1st Further Information

**Proposed Temporary Place of Recreation, Sports or Culture (Hobby Farm) with Ancillary Eating Place and Associated Filling of Land for a Period of 5 Years in "Agriculture" ("AGR") Zone and Area shown as 'Road',
Various Lots in D.D. 17 and Adjoining Government Land, Ting Kok, Tai Po, New Territories**

(S.16 Planning Application No. A/NE-TK/843)

Response-to-Comment (RtC)

Tree survey report and Landscape plan

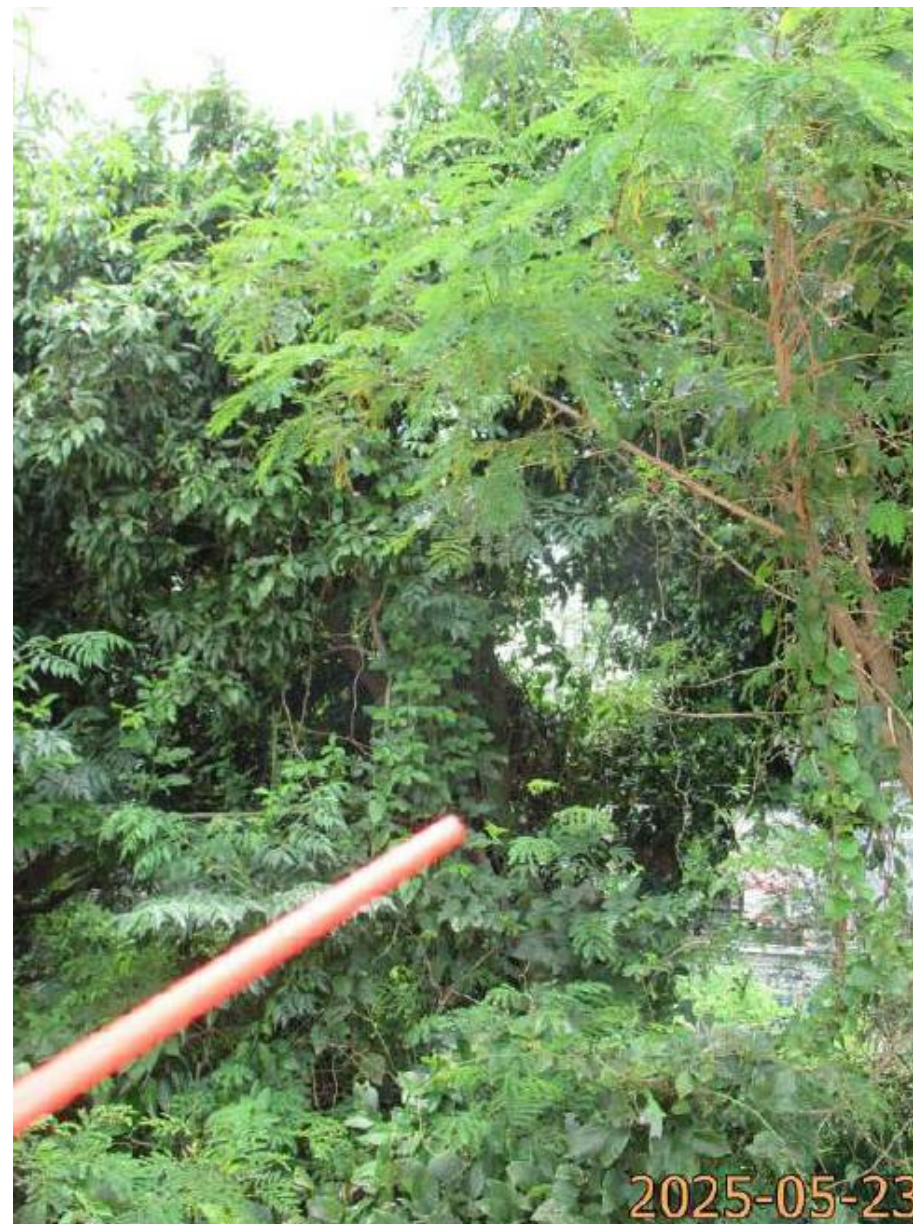
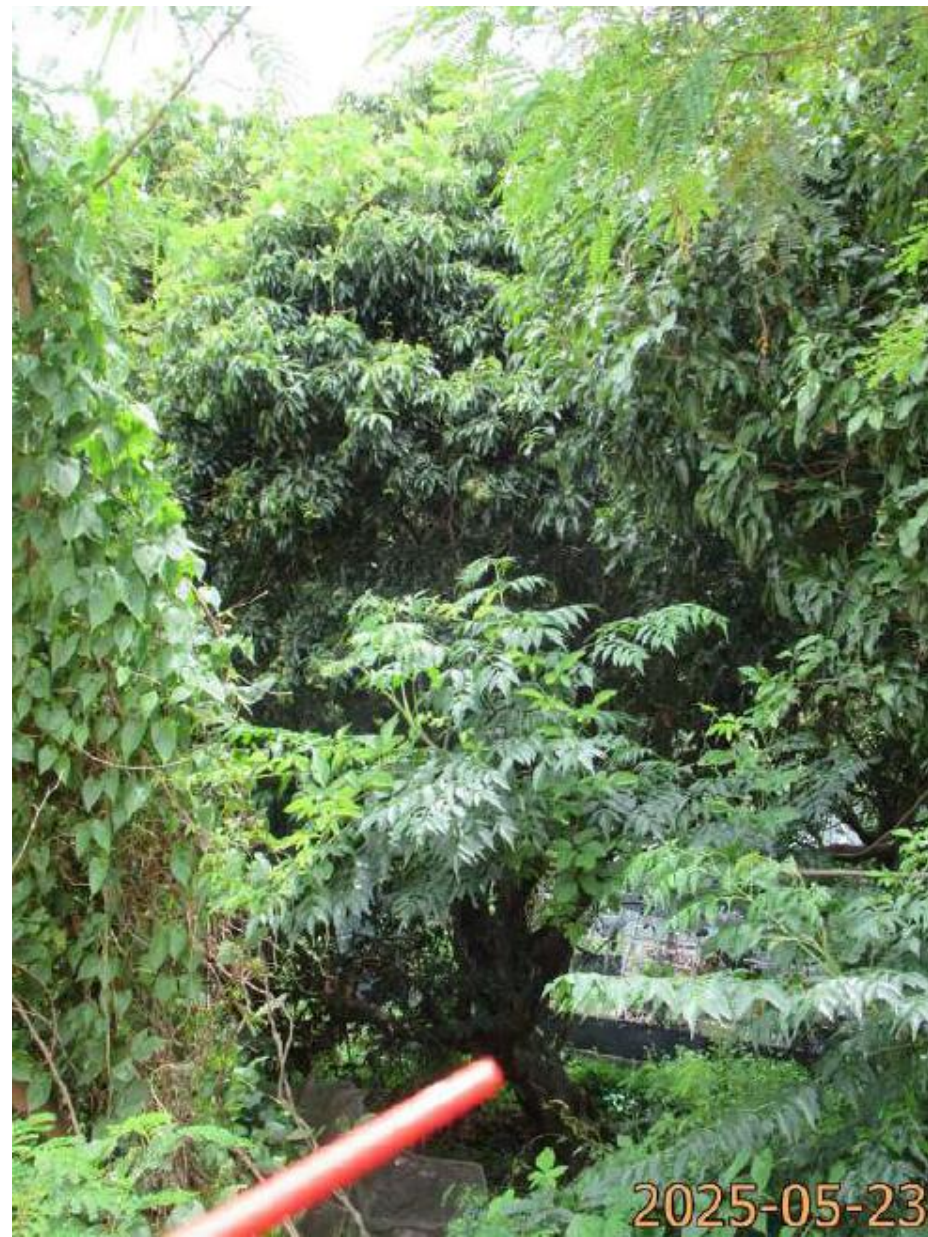
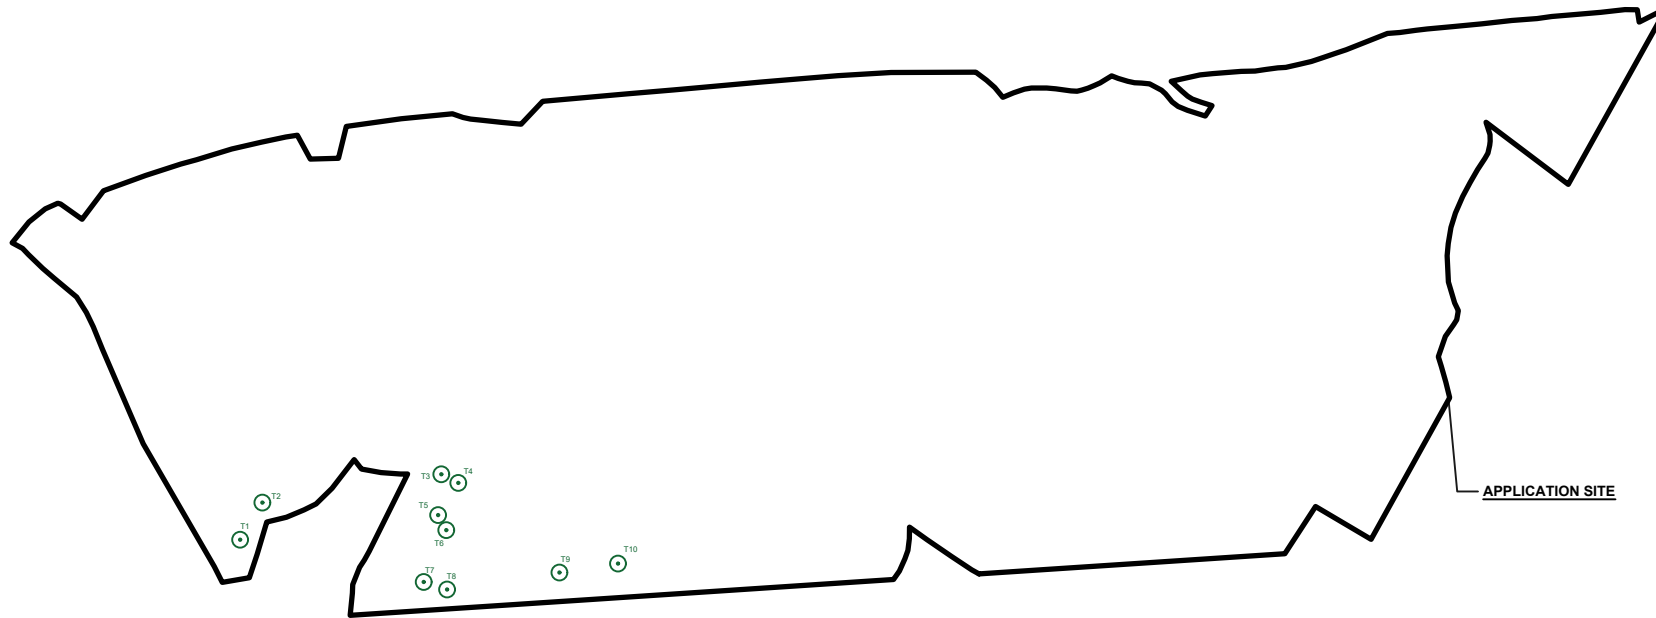
3. Comments of the Chief Town Planner/Urban Design and Landscape, Planning Department (CTP/UD&L, PlanD)		
(a)	According to the application form, tree felling is not involved. However, in para. 4.4 of the planning statement, the applicant stated "given that all existing trees will be affected it is not proposed to retain any of the existing trees at the Site." As such, it is difficult to ascertain the landscape impact of proposed development and whether tree felling will be mitigated through compensatory tree planting.	The site inspection conducted on 23.05.2025 identified 10 existing trees, including 1 dead tree within the Site. No old or valuable tree was found thereon. All existing trees, including the dead tree, will be felled as they are in conflict with the proposed development. In order to enhance the landscape quality of the Site and its surroundings, the applicant proposes to plant 17 nos. of trees of different local species, namely <i>Elaeocarpus chinensis</i> and <i>Phyllanthus emblica</i> , to compensate for the trees to be removed. The tree survey report and landscape plan are enclosed at Annex 1 .

DWG. TITLE
 LANDSCAPE PLAN

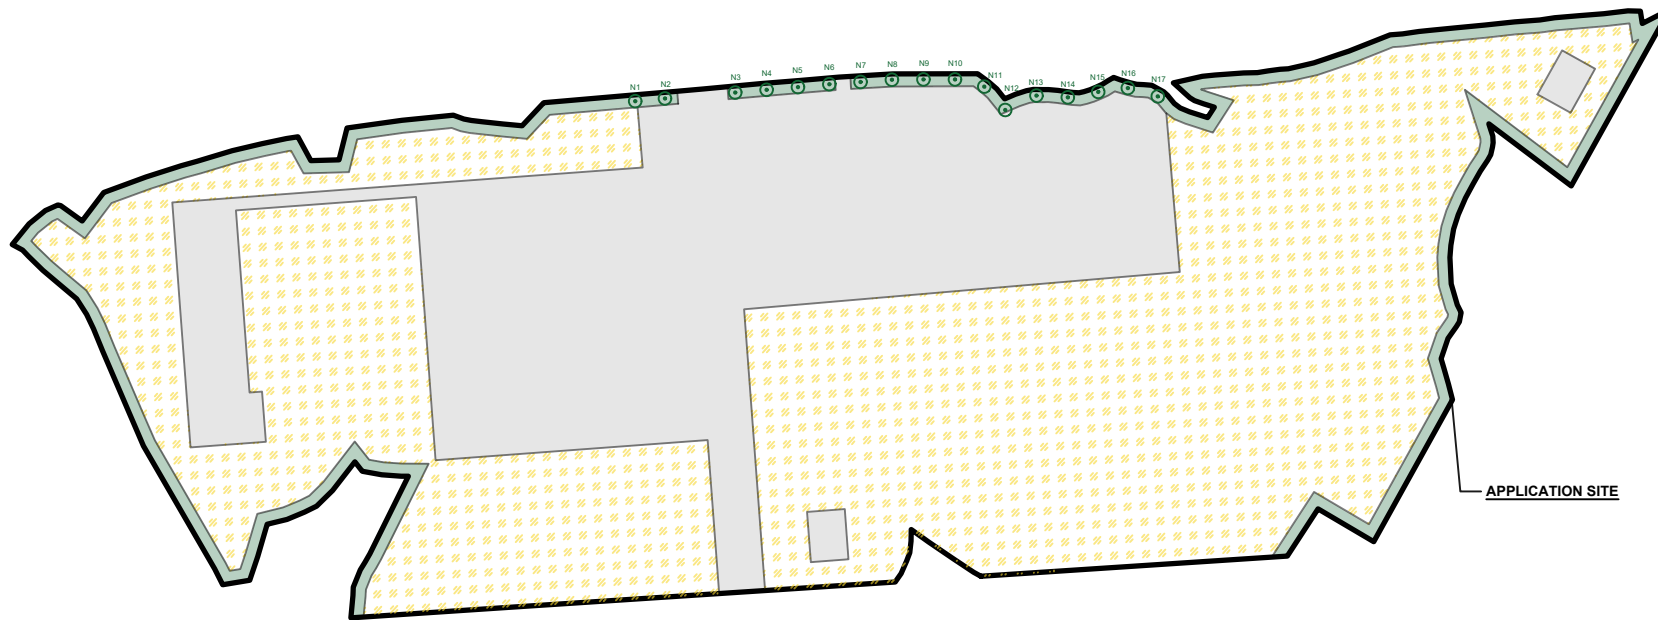
(h)	<p><u>Paragraph 4.14 of the Planning Statement</u></p> <p>It is noted that all existing trees at the Site will be affected. Please also advise (i) the number of existing trees; (ii) the number of trees to be retained/felled/transplanted; and (iii) and any compensatory trees to mitigate landscape impacts caused by the proposed use within the Site.</p>	Please refer to applicant’s responses to CTP /UD&L, PlanD in Part 3 of this table.

- in order to enhance the landscape quality of the Site, the applicant proposes to plant new trees of different local species, namely *Elaeocarpus chinensis* and *Phyllanthus emblica*, at the Site. The wind, drought and/or salt spray tolerance nature of the selected species are considered suitable to provide further landscape quality to the Site. For details of the existing and proposed trees, please refer to the landscape plan at **Annex 1**. Besides, the farming nature of the proposed development is expected not to significantly affect the landscape quality of the Site;

DWG. TITLE
LOCATION OF NEARBY ACCESS

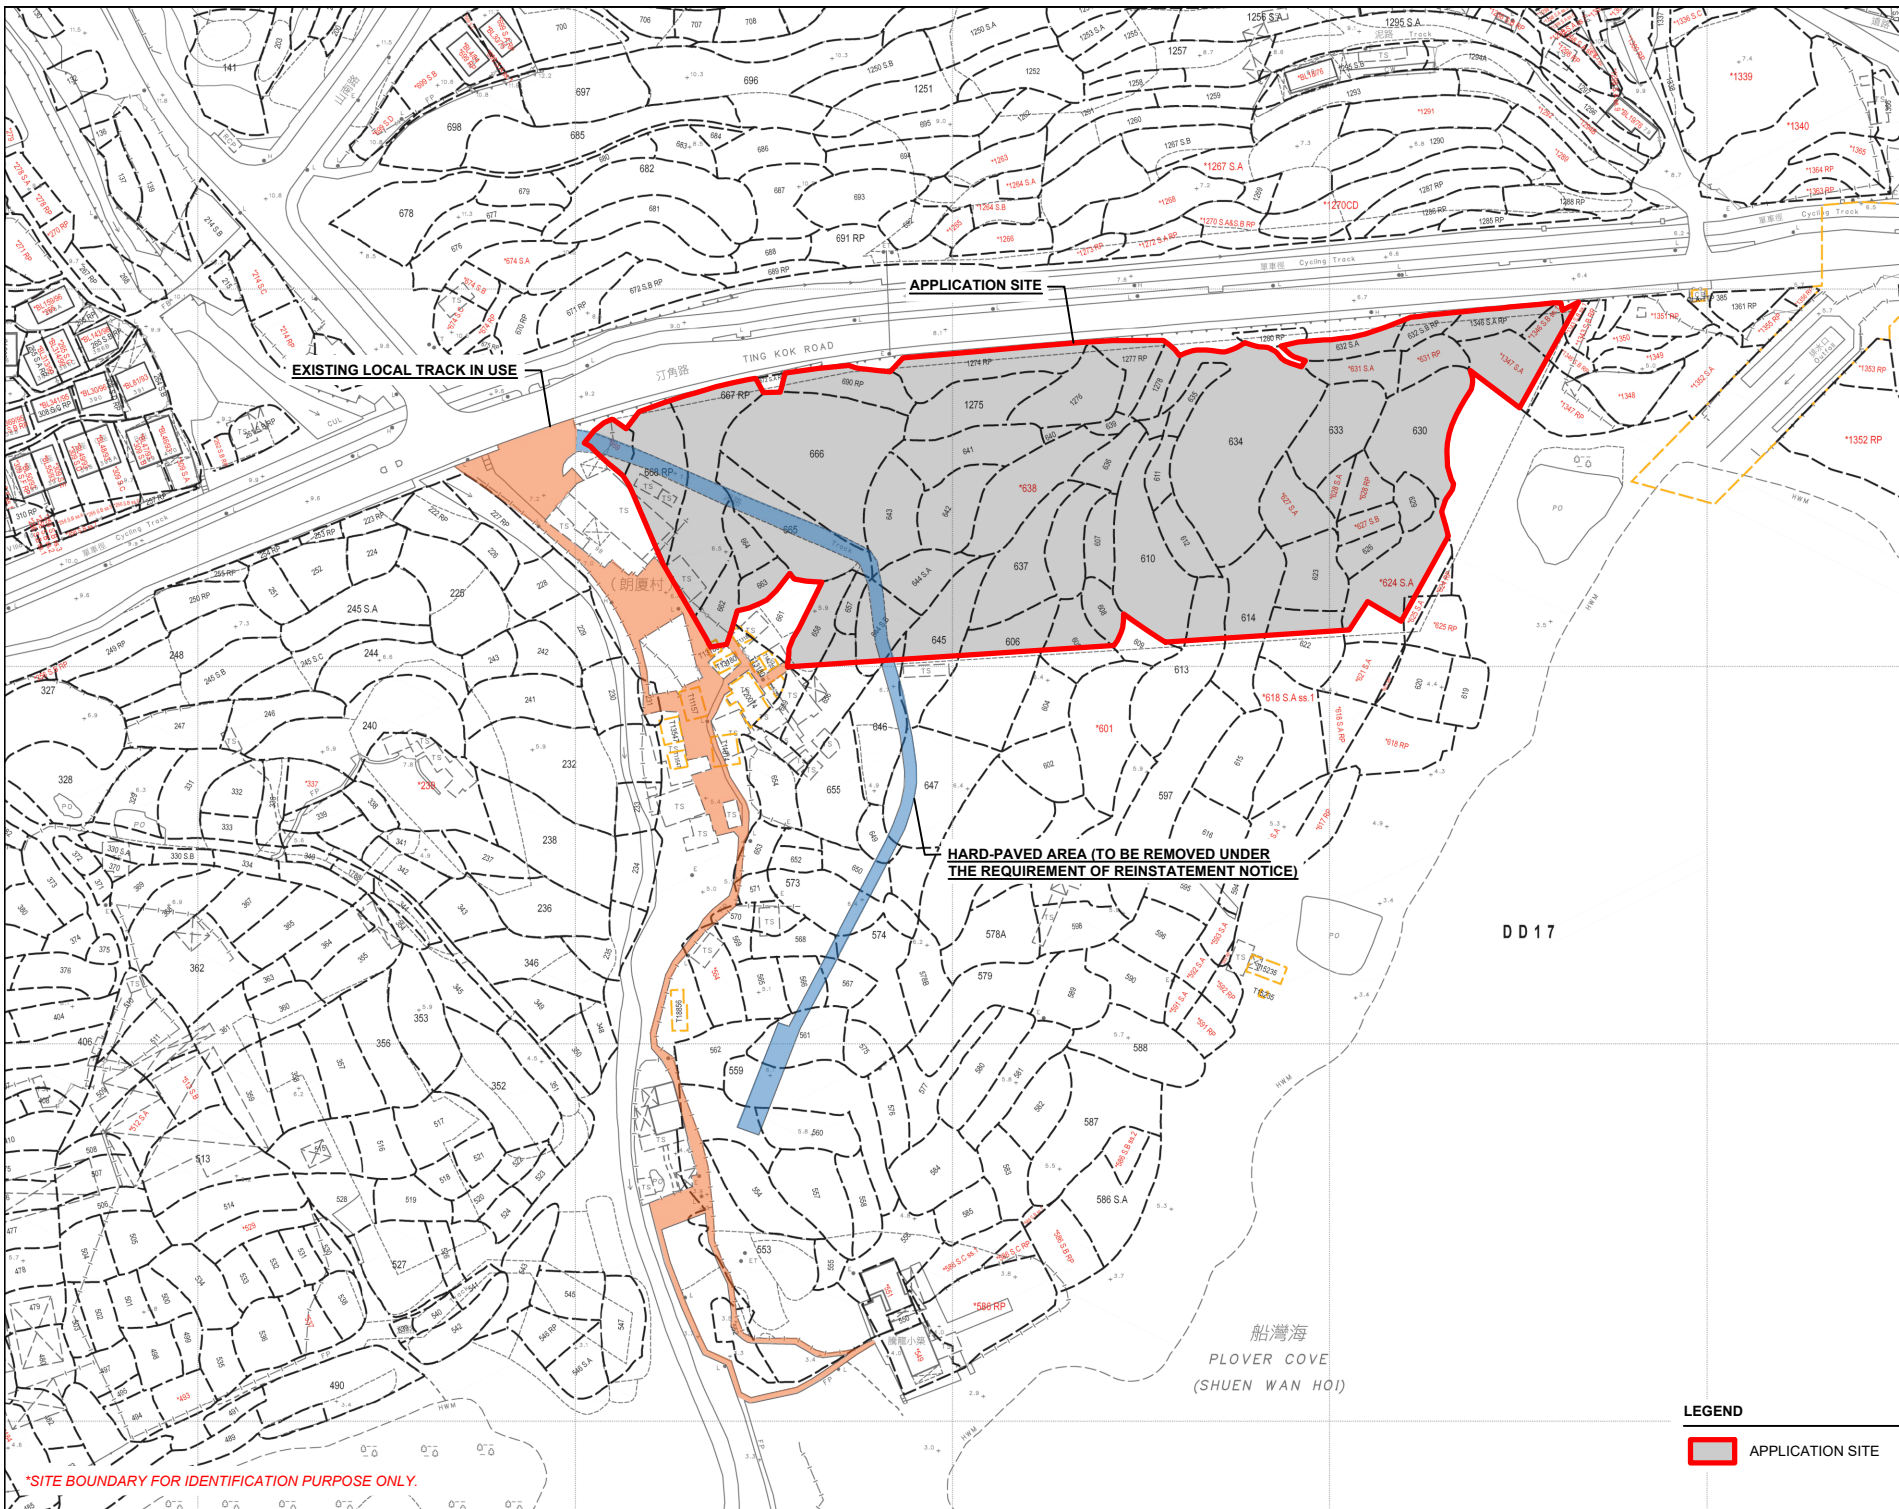
(k)	The western portion of the Site encroaches onto an existing local track connecting between Ting Kok Road and the area to the south of the Site. Noting that the proposed use will lead to blockage of the local track, please advise (i) whether any re-provision of the local track would be proposed and (ii) whether there are any alternative route(s) for such connection.	<p>The local track has been considered part of an unauthorised development by the Planning Authority, who issued a Reinstatement Notice (RN) to the concerned lot owners in July 2025 requesting the removal of hard-paving. The applicant has been conducting works to remove the existing hard-paving and grass the concerned area in accordance with the requirements stipulated on the RN, with a view to avoid further prosecution action from the Planning Authority.</p> <p>The area to the south of the Site is currently accessible via a local track located to the west of the Site. Please refer to Annex 2 for its location.</p>
